# City of Plymouth Planning Commission

## Regular Meeting Agenda

**Special Land Use and  
Site Plan Review  
For  
Plymouth, Michigan**

<b>Applicant:</b>	Taylor Family Properties Scott Taylor/Holly Ellis 17946 Stonebrook Ct. Northville, MI 48168
<b>Project Name:</b>	Plymouth Freight House Mixed-Use Proposal
<b>Plan Date:</b>	July 19, 2024
<b>Location:</b>	904 Starkweather
<b>Zoning:</b>	MU – Mixed-Use District
<b>Action Requested:</b>	Special Land Use and Site Plan Approval
<b>Required Information:</b>	Any deficiencies are noted in the report.

**SITE PLAN**  
904 STARKWEATHER  
LOT 589 EXCEPT N. 30', AND ALSO W. 8' OF LOT 564  
ASSESSOR'S PLYMOUTH PLAT No.17 SEC. 23,T.1S.,R.8E  
CITY OF PLYMOUTH, WAYNE COUNTY, MICHIGAN

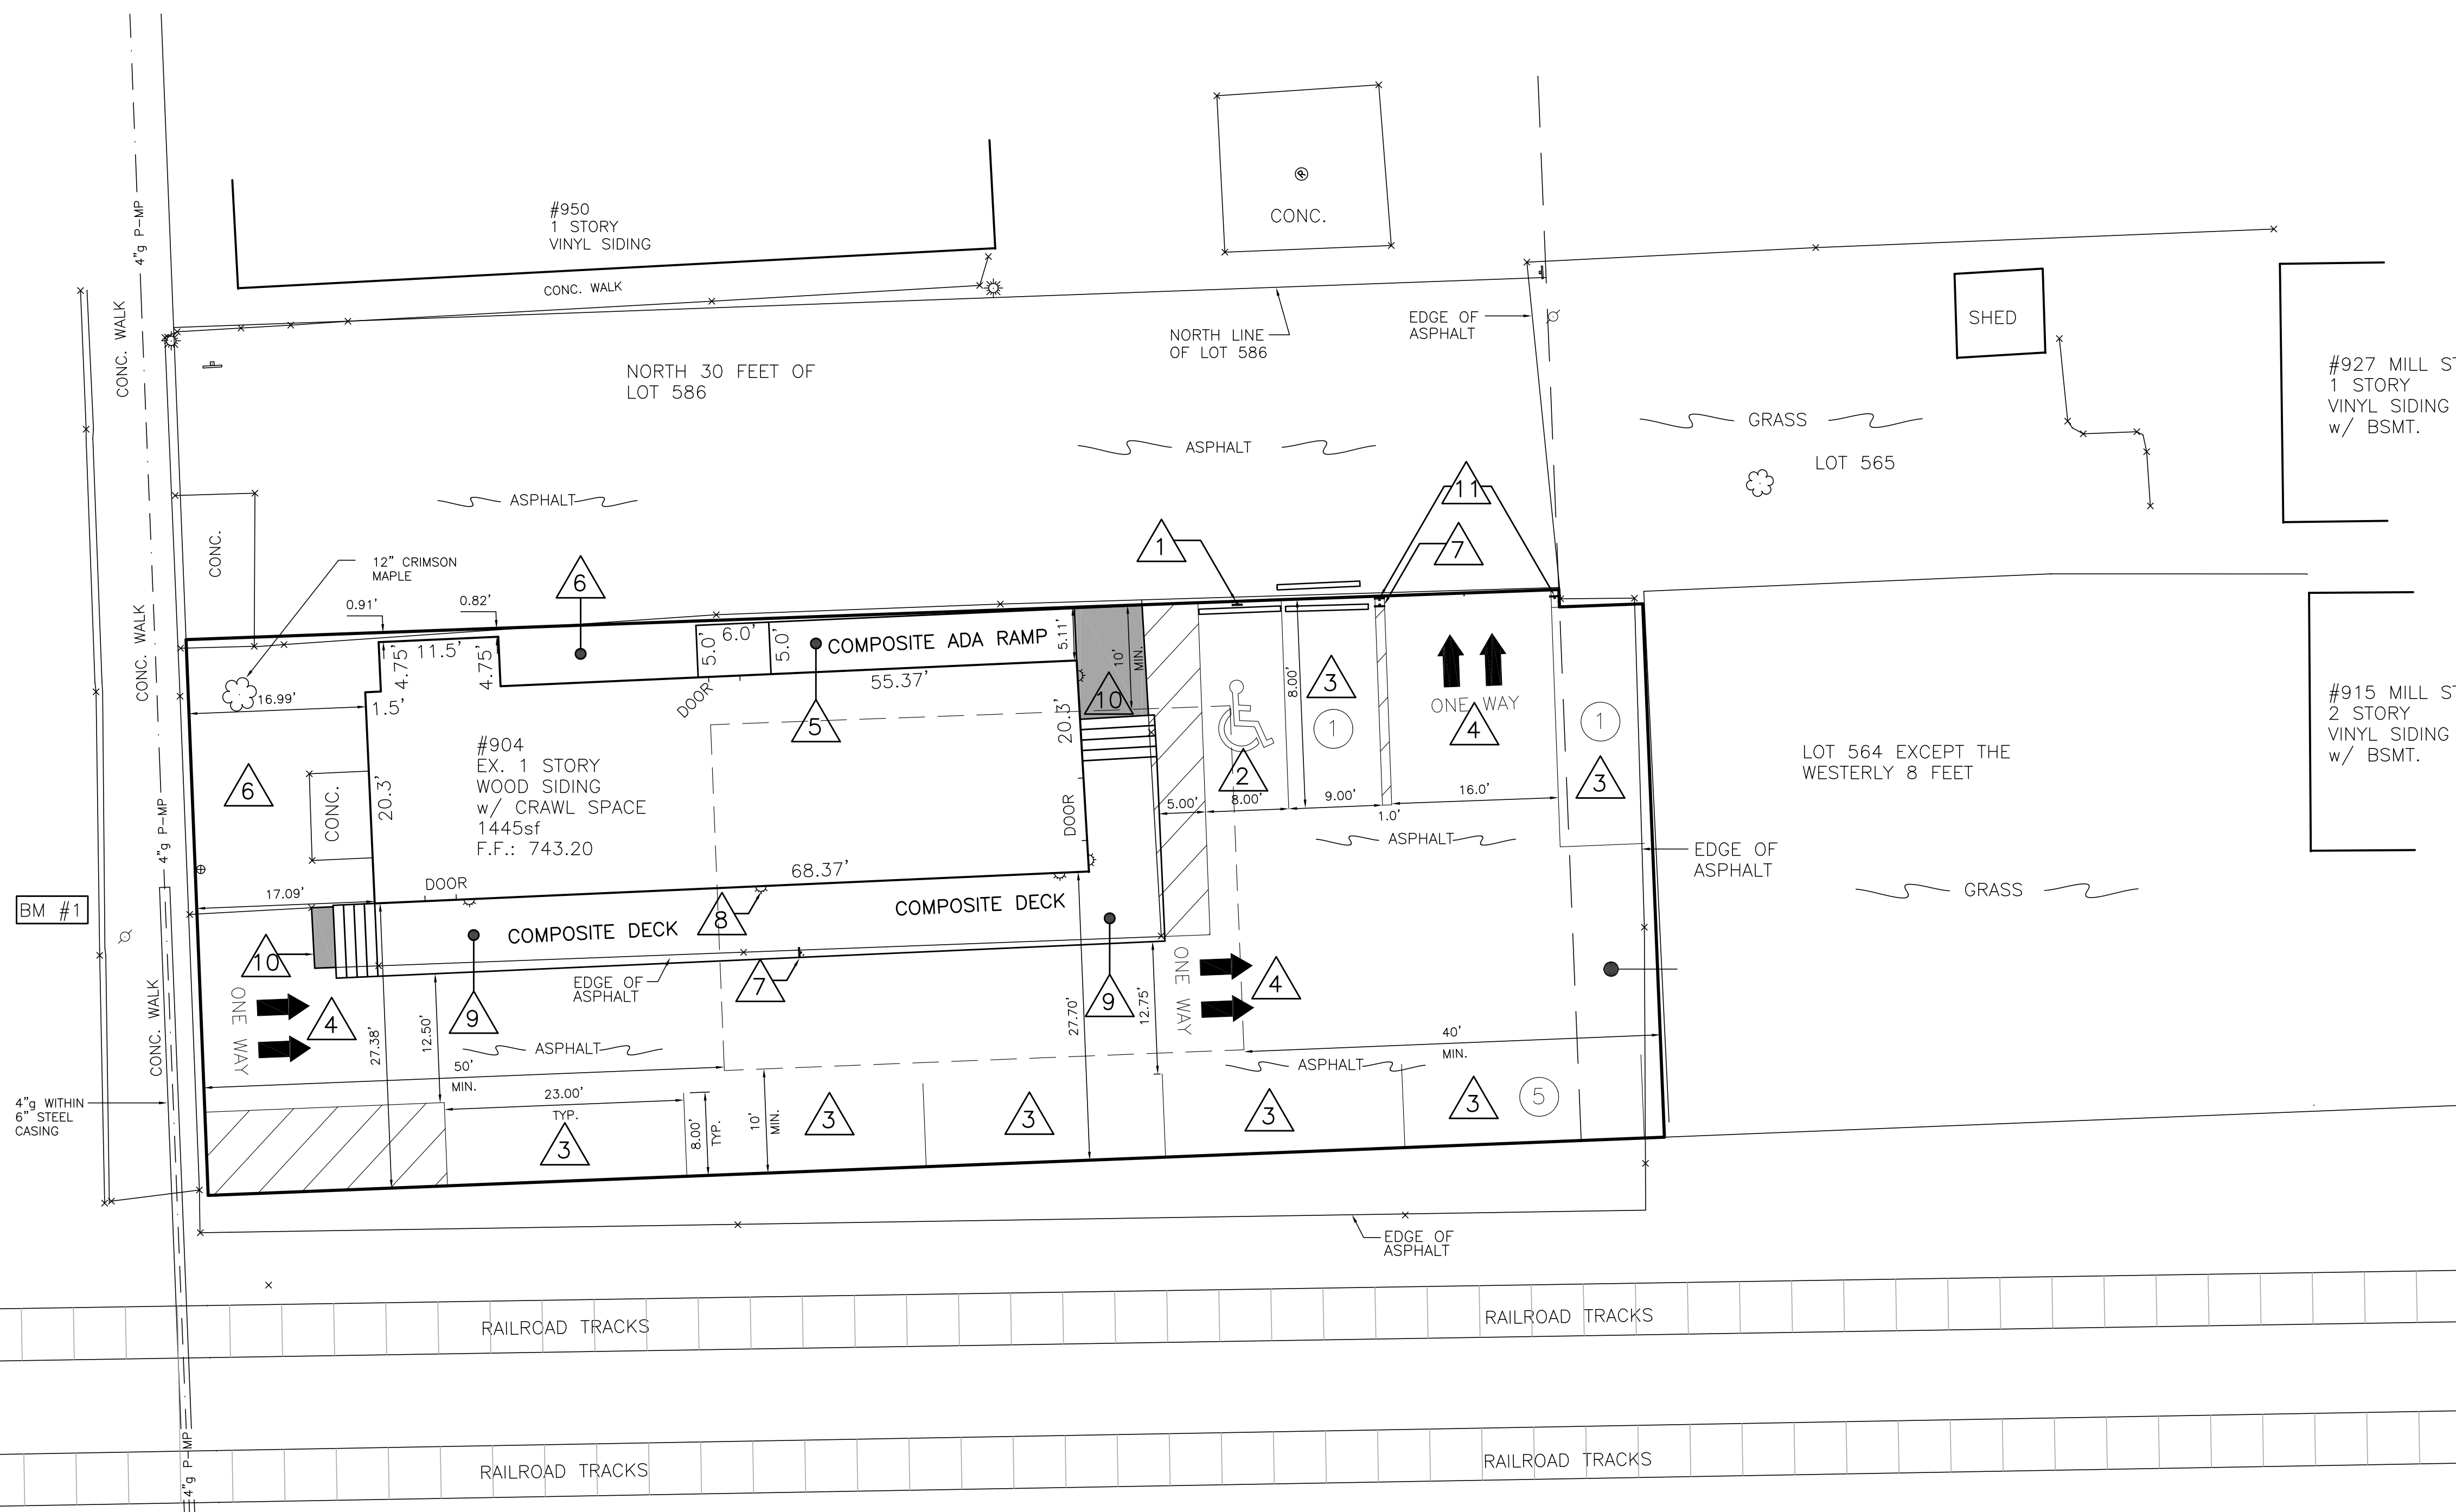
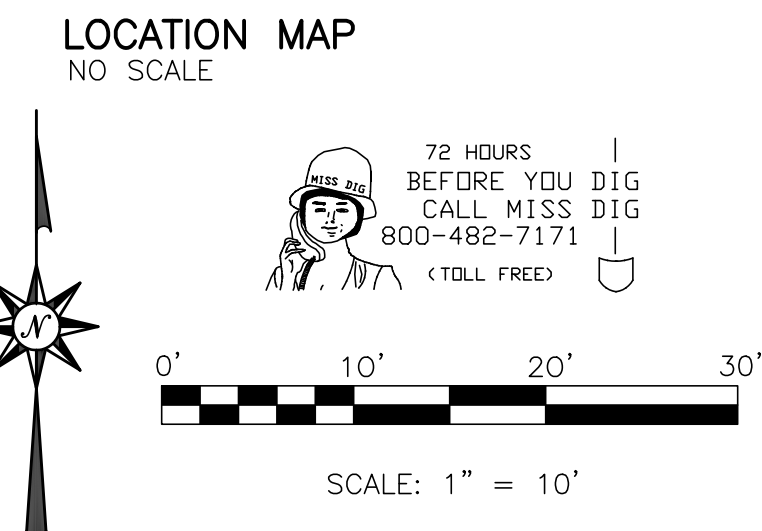
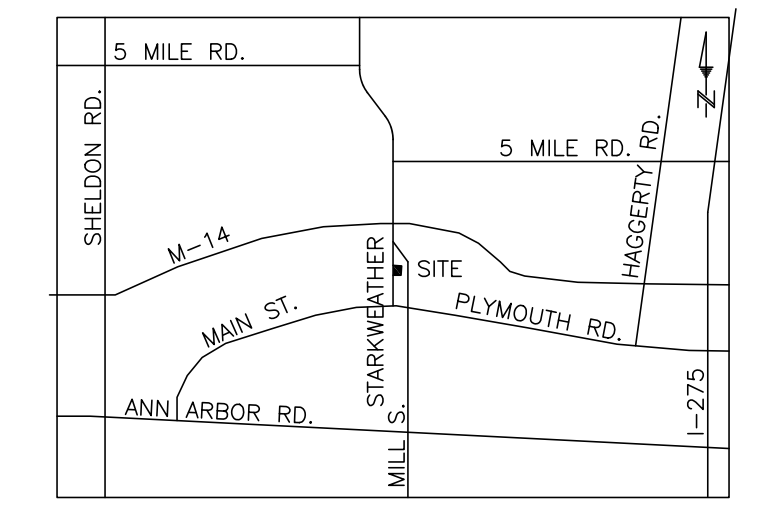
**Barrier-Free Parking.** At least one (1) barrier-free space, sized as a “van-accessible space” with an 8-foot wide aisle, needs to be shown on the plans. The proposed barrier-free space shown on the plans has a five-foot wide aisle.

The existing parking lot extends up to the side and rear property lines, and does not provide the required setbacks. The five-foot setback requirement may be waived by the Planning Commission for sites where there is limited land area available to meet it, or where it is possible to provide additional landscaping or screening to buffer parking from a public road right-of-way. Sec. 78-351(b)(3)(f)(3) requires that landscape buffer strips shall be installed between the right-of-way and parking lot, per Sec. 78-203. Therefore, if the applicant were to install a landscaped buffer in the new striped area between the right-of-way and the first parallel parking space, then the Planning Commission may waive the 5-foot-wide buffer requirements. This landscaped area would also help to protect the car parked in the most westerly parallel parking space.

**Parking Lot Circulation.** The plans show a circulation pattern where vehicles will enter the lot from Starkweather, and leave the lot via a drive aisle that connects with the property to the north. This proposal will require a shared access agreement with the northern property owner. This layout also eliminates at least two parking spaces on the neighbor's property. The applicant should provide information to confirm that the neighbor (property to the north) can lose two parking spaces to the access easement and still meet the minimum parking requirements.

The applicant's narrative states that the existing lighting will remain, and that they will be adding light fixtures at the front and rear entrances. The Site Plan shows the addition of four (4) Wallpack lights to the south and east side of the building. This inconsistency should be explained via submission of a photometric plan, with specifications of proposed light fixtures, showing the proposed light levels on the site.

The Site Plan notes that no utility work is proposed at this time. The applicant's narrative states that: *"The front hedge, rock bed, and business sign will be removed to accommodate work on the HVAC and plumbing systems."* The inconsistency should be explained.

**Items to be Addressed:** 1) Applicant to floor plans of the renovated building. 2) Applicant to provide "usable" floor area and maximum occupancy figures on plans. 3) Widen barrier-free aisle to 8-feet wide to create "van-accessible" space. 4) Applicant to consider adding at least one bike rack to the site. 5) Site plan to indicate where loading/unloading will occur on site; provide anticipated delivery schedule and type/size of delivery vehicles. 6) Planning Commission to consider waiving 5-foot parking setback requirement based on the applicant providing a landscape buffer between the street right-of-way and parallel parking spaces (or in the area of striped pavement next to Starkweather sidewalk), and to help protect vehicles parallel parked from vehicles that are entering the site. 7) Applicant to clarify how the parking lot is screened from the residential neighbor. 8) Applicant to provide executed cross access agreement with property owner to the north to allow vehicles from this site to exit onto their property. 9) Information provided to confirm that property to the north can lose two parking spaces to the cross access easement and still meet the minimum parking requirements.

**Items to be Addressed:** 1) Applicant to provide photometric plan, with specifications of proposed light fixtures.

**Items to be Addressed:** 1) Applicant to clarify changes to utilities.

**Figure 3: Possible Location of Landscaped Buffer Stipe between Right-of-way and Parking Lot**

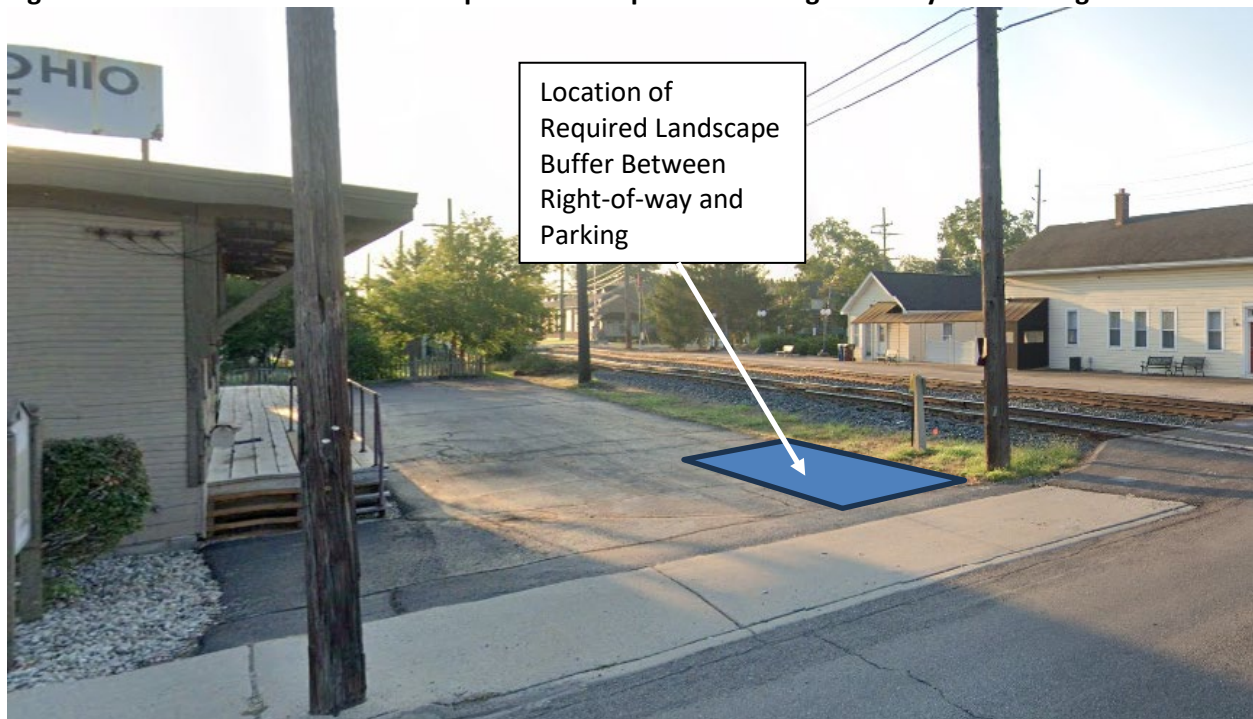
Also, it doesn't appear that there is a screening wall, fence or berm along the rear property line (next to the residential property). The applicant should clarify how this lot is screened from the residential neighbor.

- 6) Planning Commission to consider waiving 5-foot parking setback requirement based on the applicant providing a landscape buffer between the street right-of-way and parallel parking spaces (or in the area of striped pavement next to Starkweather sidewalk), and to help protect vehicles parallel parked from vehicles that are entering the site.
